June 6, 2023

Ref: Acorn Place  
Stormwater Basin Modifications

ACORN PLACE  
STORMWATER BASIN 1  
MODIFICATION  
PLAN OF LAND IN  
MILLIS, MA

ACORN PLACE  
STORMWATER BASIN 2  
MODIFICATION  
PLAN OF LAND IN  
MILLIS, MA

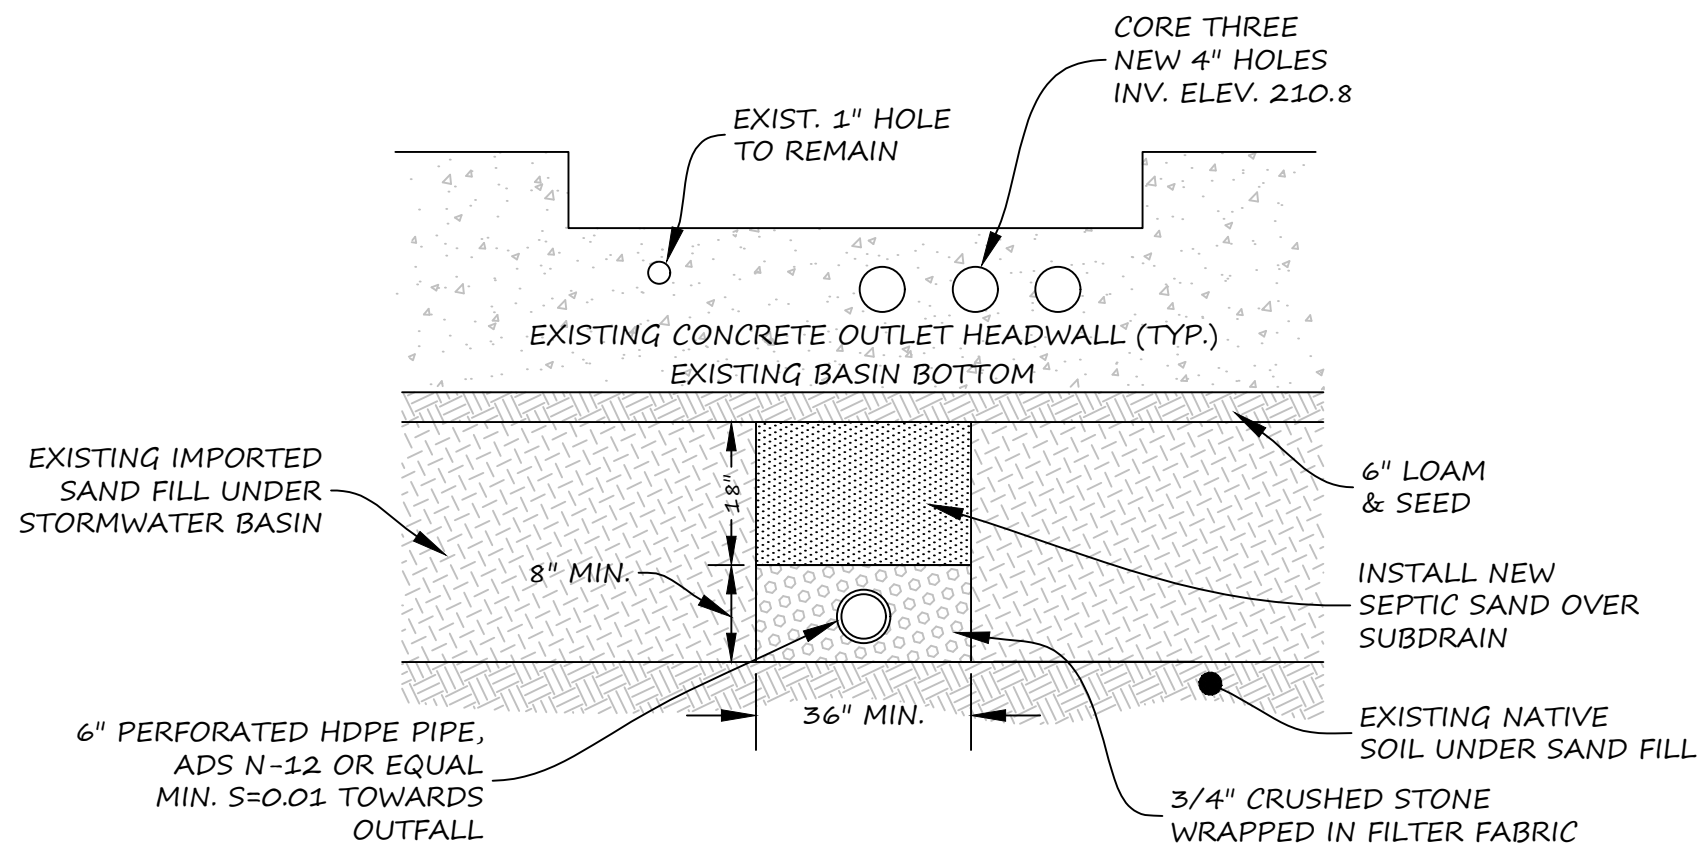
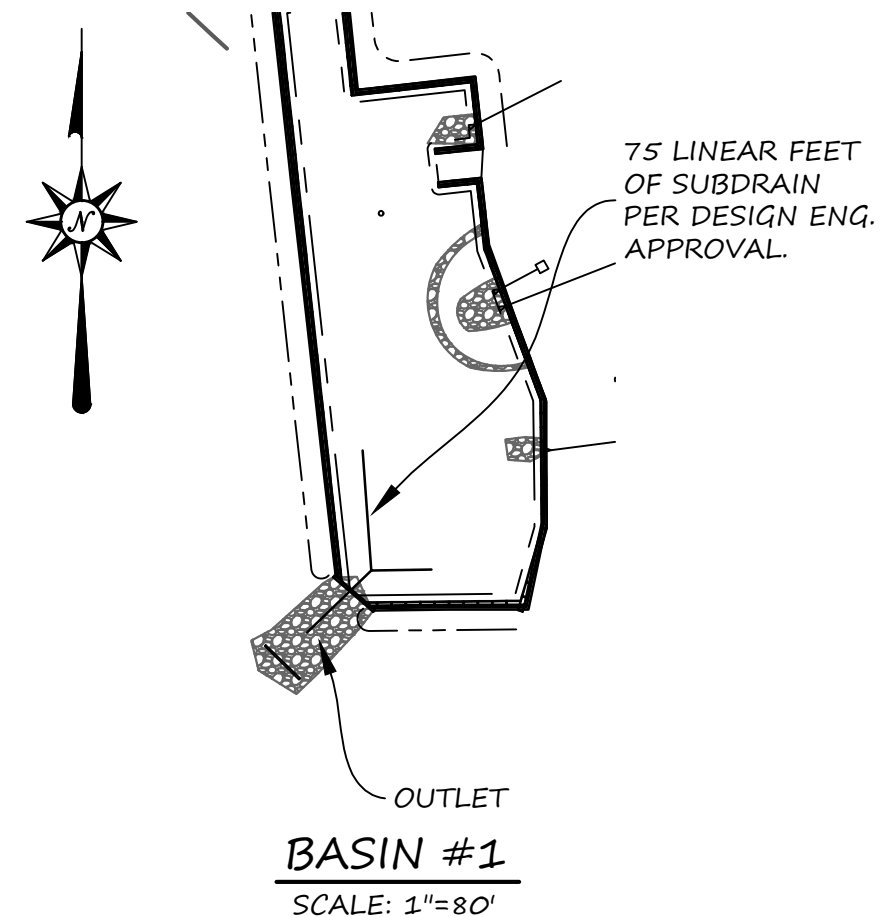
The installation of a subdrain into both basins provides a potential solution. It will allow for the basin and the sand layer below it to drain out slowly, thus preventing excessive periods of standing water. In order to demonstrate compliance with 80% TSS removal, as has been suggested by BETA, given that both basins have a substantial layer of imported sand under the loam and above the native soil, the water trapped below the lowest outlet in each basin will have to infiltrate through the loam and sand before it can be captured by the new subdrain and discharged. This operates in the same manner as a sand filter as described in the DEP Stormwater Handbook. A sand filter achieves 80% TSS removal with one pretreatment BMP. Each basin is preceded by either deep sump catch basins, a sediment forebay, or both, thus meeting the 80%TSS requirement. Based on commentary from BETA, the attached details have been revised accordingly. For Basin 2, given the existing ground

elevations at the outfall, the subdrain can be placed below 18" of sand. For Basin 2, given the existing ground elevations at the outfall, the subdrain can be placed below 9" of sand. That in combination with the loam layer provides 15" of soil above the top of the subdrain. We note, however, that this would only impact the area immediately above the subdrain, as all other flows to the subdrain must pass through the loam and then laterally through the sand layers to reach the subdrain. We view this as reasonable given the site constraints.

For Basin 1, the elimination of infiltration in the Hydrocad model only resulting in an increased peak rate of runoff in the 100-year storm. Thus, additional low-flow outlets are proposed to change the stage-discharge model to allow all peak rates to be lowered. In order to maintain the Water Quality Volume storage within the basin (4,332 c.f.), three additional 4" diameter cores are proposed to be added to the headwall at elevation 210.80, which results in a raw standing volume of 4,981 c.f. within the basin. These three new outlets will be 0.2 feet lower than the existing low-flow outlet, reducing the depth of standing water in the basin to 0.3 feet. This modification yields the following as indicated in the attached Hydrocad model:

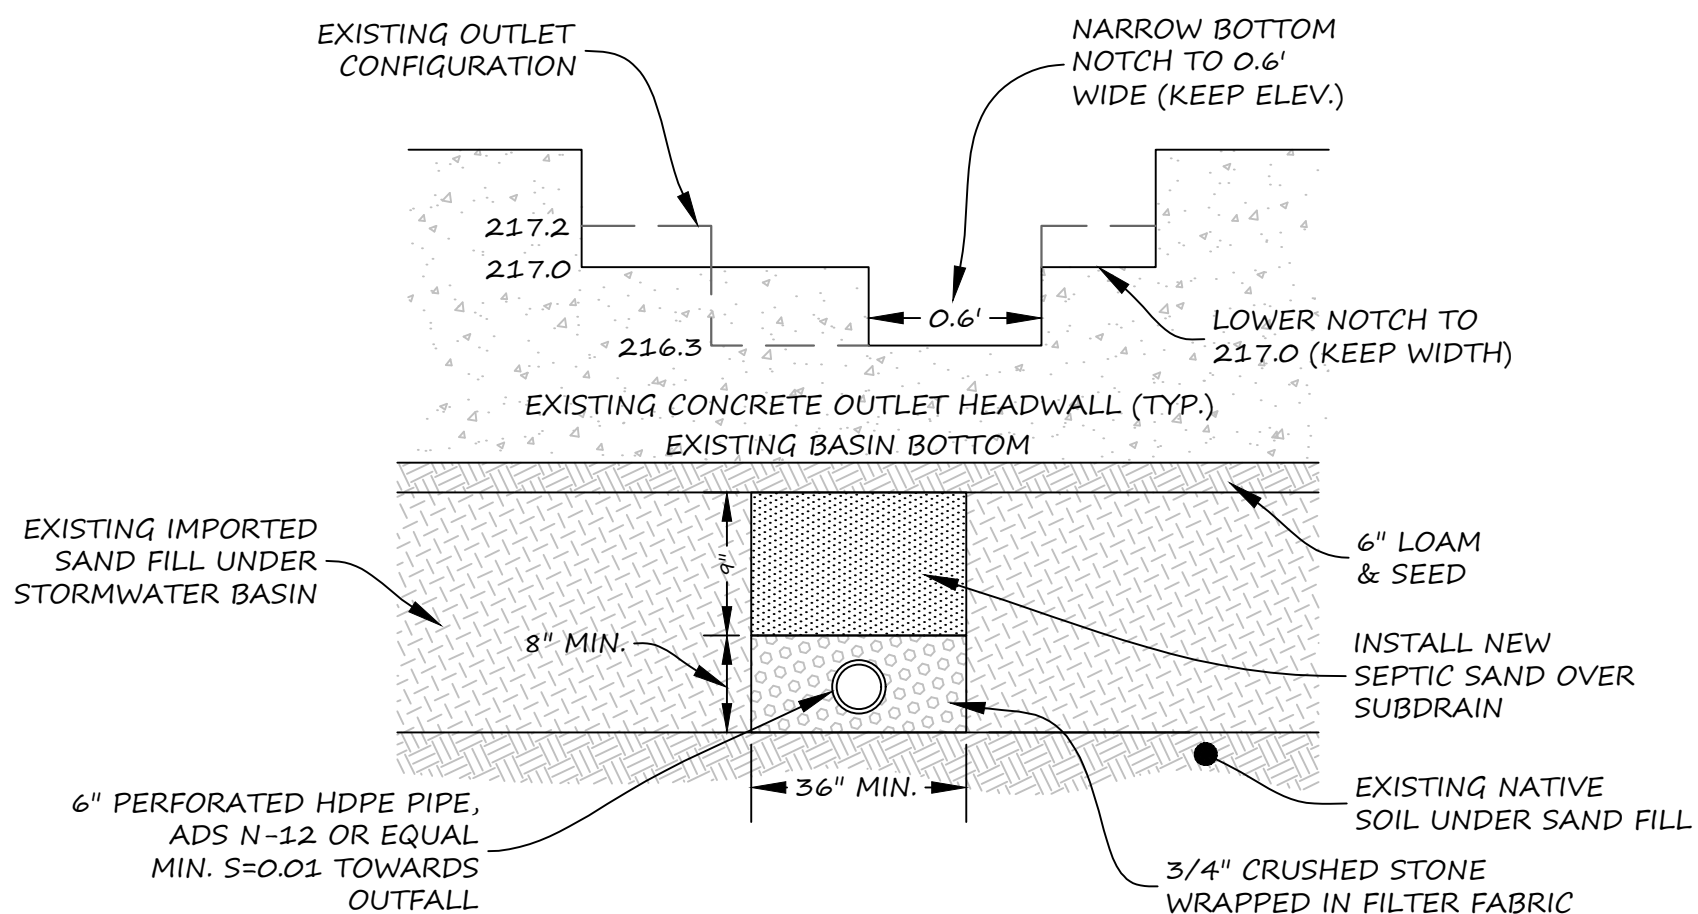
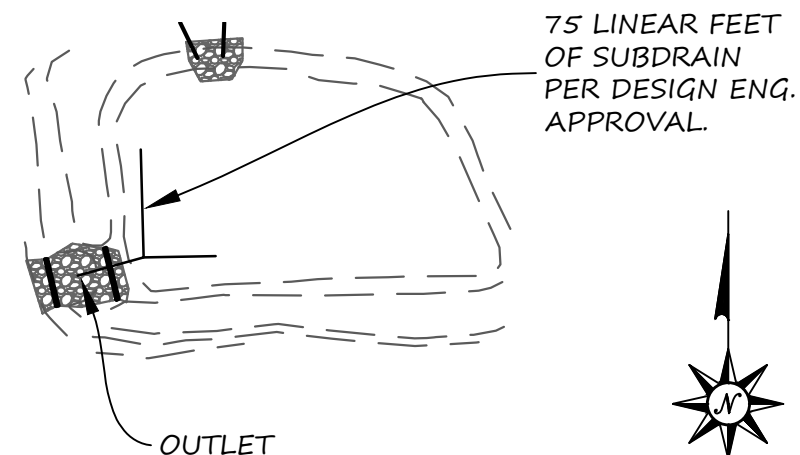
For Basin 2, the elimination of infiltration in the Hydrocad resulting in small peak rate increases in all storm events. Thus, to accommodate the revised stage-storage relationship with no infiltration included, the outlet notch is proposed to be modified per the detail in attachment C. This modification yields the following as indicated in the attached Hydrocad model:
